JR-039

Re: Governor's Land - River Oaks North
County Plan No. ~~S-14-93~~ S-12-96
Stormwater Management Facility
County BMP ID Code: JR 034

The Environmental Division has reviewed a record drawing and a postconstruction geotechnical report (ECS #6221 dated December 31st 2000) as submitted to our office for the above referenced BMP. The record drawing provides as-built information for Wet Pond # 3 situated near the cul-de-sac at the west end of River Ridge Road.

BMP #3 CONSTRUCTION PLAN
 GOVERNOR'S LAND: RIVER OAKS NORTH, BAYS, POD4
 JAMES CITY COUNTY, VIRGINIA

DRAWN BY: 10W/ACAD
 DESIGNED BY: 10W
 DATE: 5/14/06
 CHECKED BY: SB/ZA/BL
 SHEET: 10C
 10B of 91

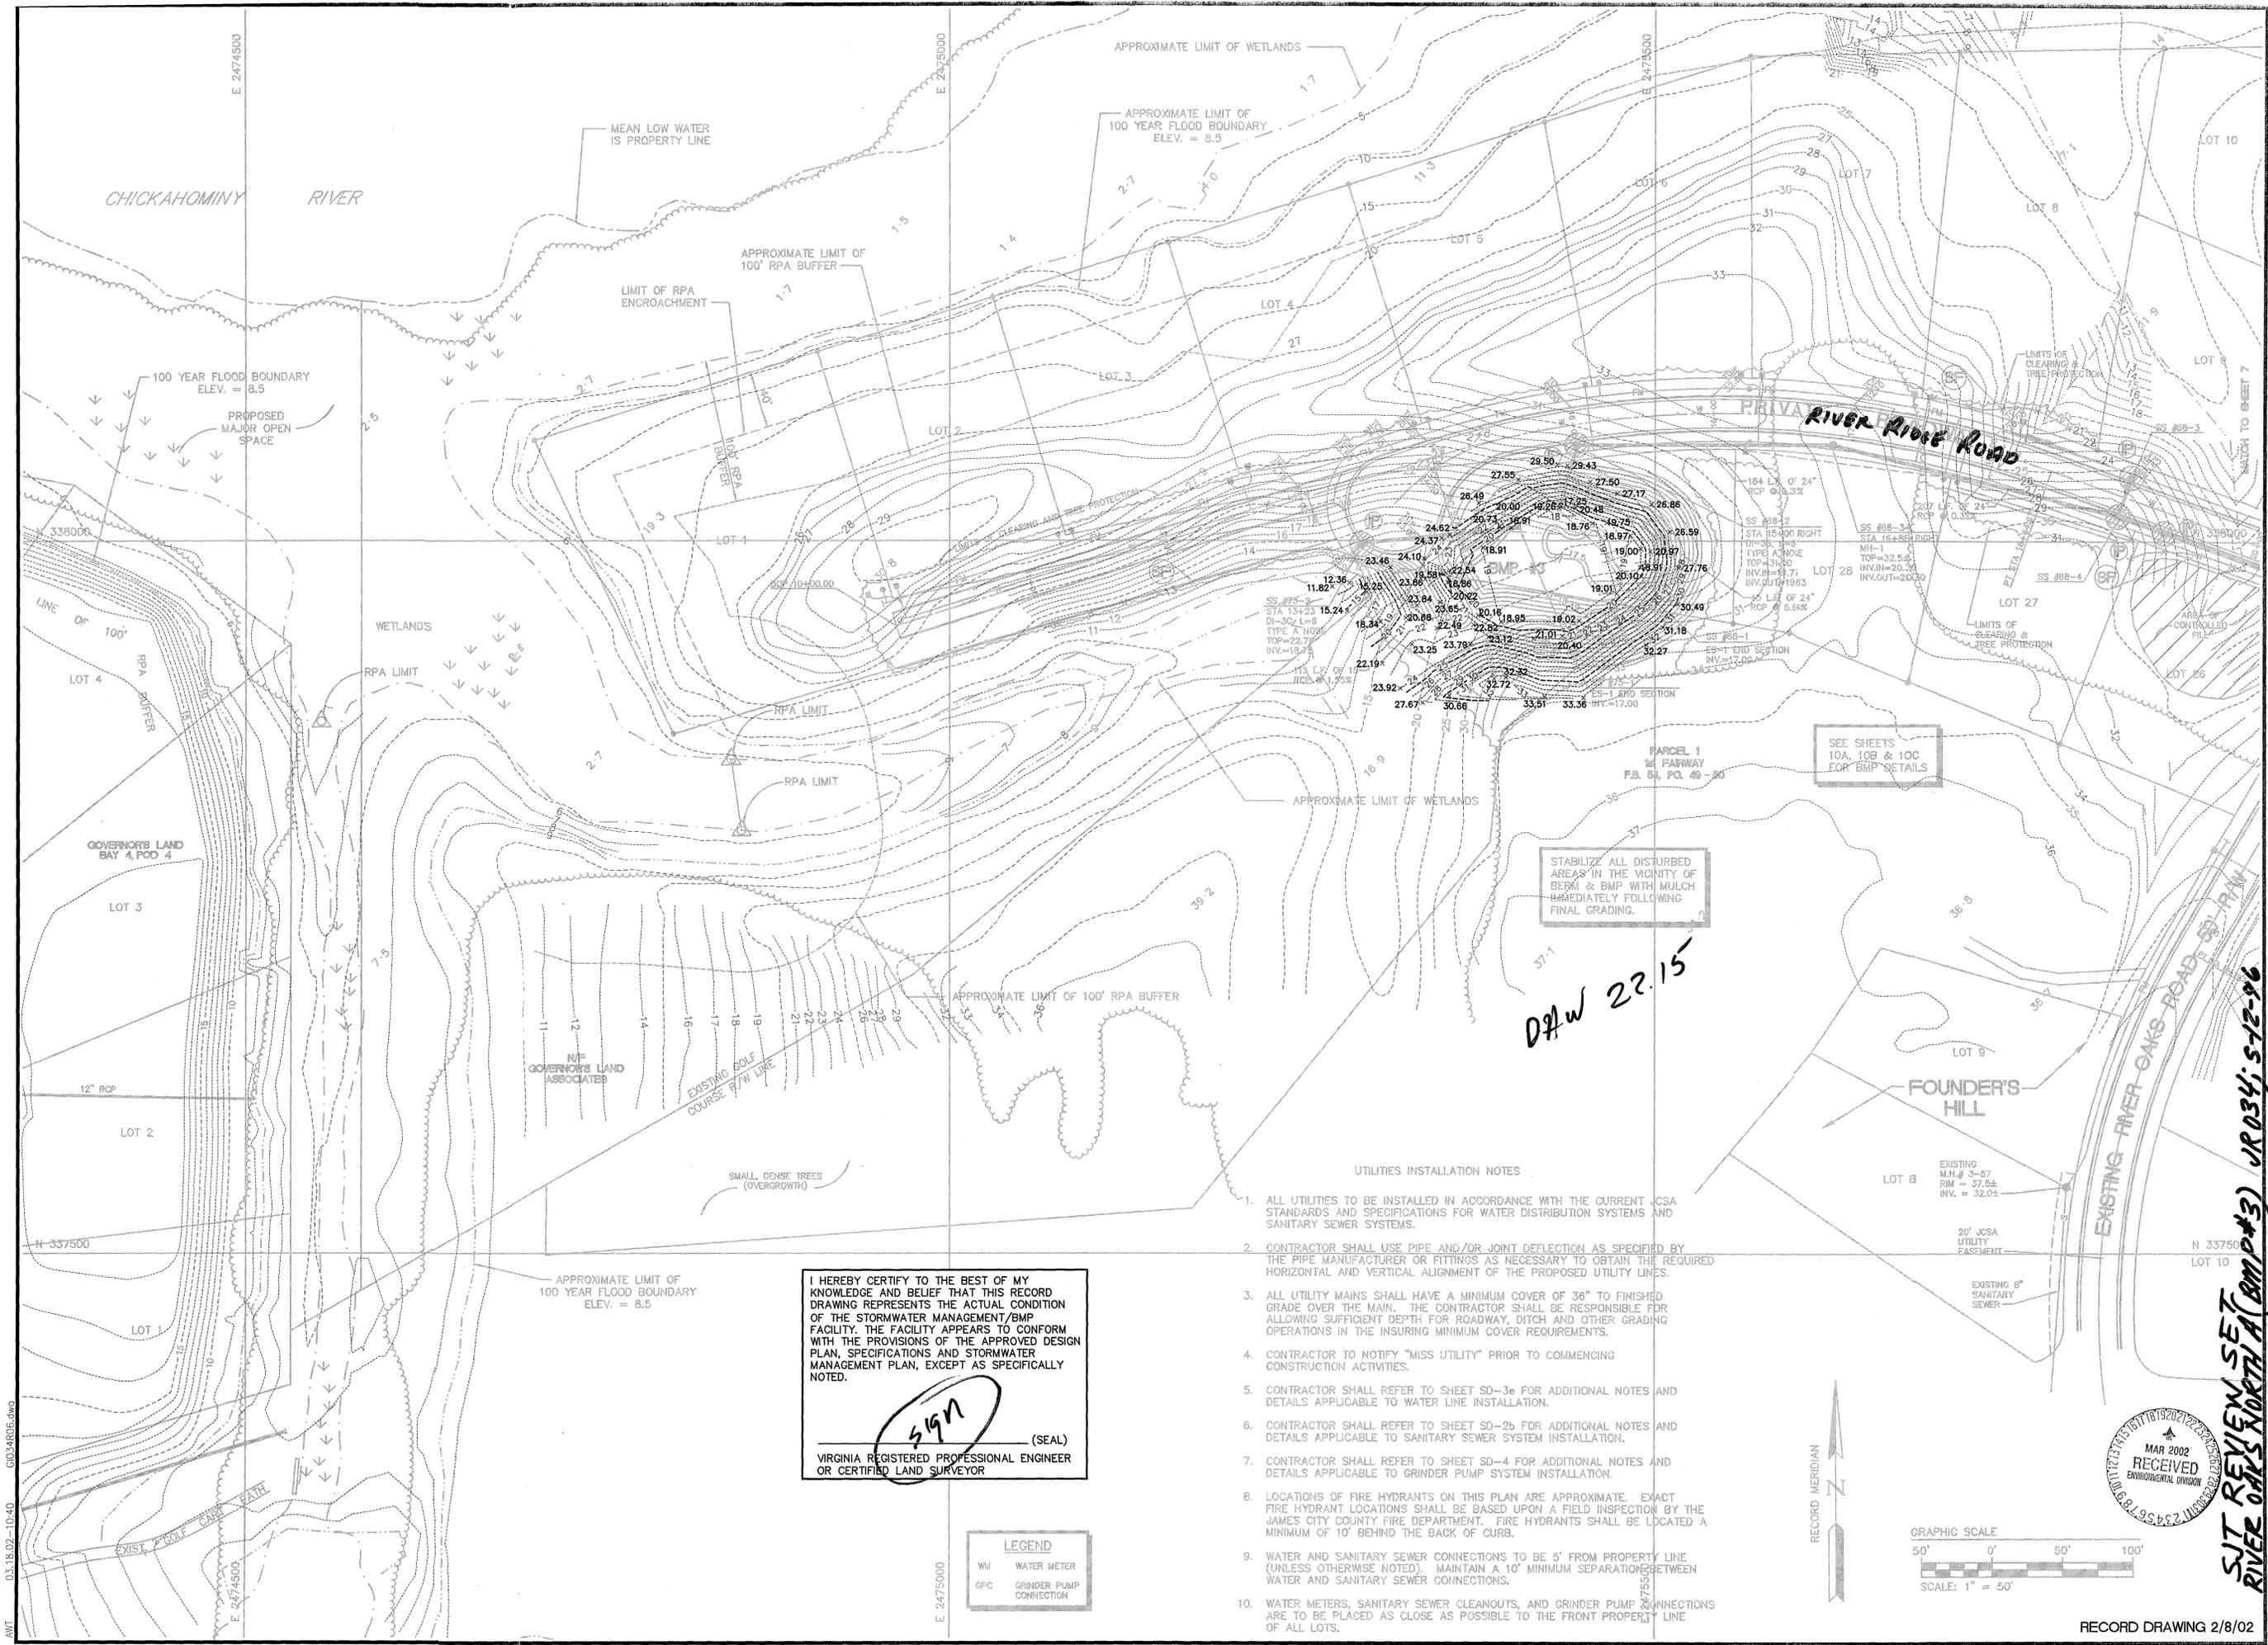
- 2. The professional certifications on both sheets of the record drawing set are blank and require signature and date.
- 3. Provide asbuilt spot elevations or contours for the bottom of the pond to show that the shallow marsh bottom and pond arrangement was constructed in accordance with the approved plan and that excessive sedimentation does not exist in the bottom of the facility. Record drawing Sheet 2 plan, section and profiles indicate a proposed bottom elevation at El. 17.0 with high marsh areas and forebays at the outfall of incoming storm drain pipes.

- 4. Provide asbuilt information for incoming storm drain pipes which enter the BMP including approximate location, size and invert elevations for the outlet ends of the pipes.

2. The professional certifications on both sheets of the record drawing set are blank and require signature and date.
3. Provide asbuilt spot elevations or contours for the bottom of the pond to show that the shallow marsh bottom and pond arrangement was constructed in accordance with the approved plan and that excessive sedimentation does not exist in the bottom of the facility. Record drawing Sheet 2 plan, section and profiles indicate a proposed bottom elevation at El. 17.0 with high marsh areas and forebays at the outfall of incoming storm drain pipes.

4. Provide asbuilt information for incoming storm drain pipes which enter the BMP including approximate location, size and invert elevations for the outlet ends of the pipes.

Spot elevations for the bottom of the pond were added to plan view of the drawings. From this information, there is no significant sediment accumulation in this pond.

Added approximate location, size and invert elevations for incoming storm drain pipes.
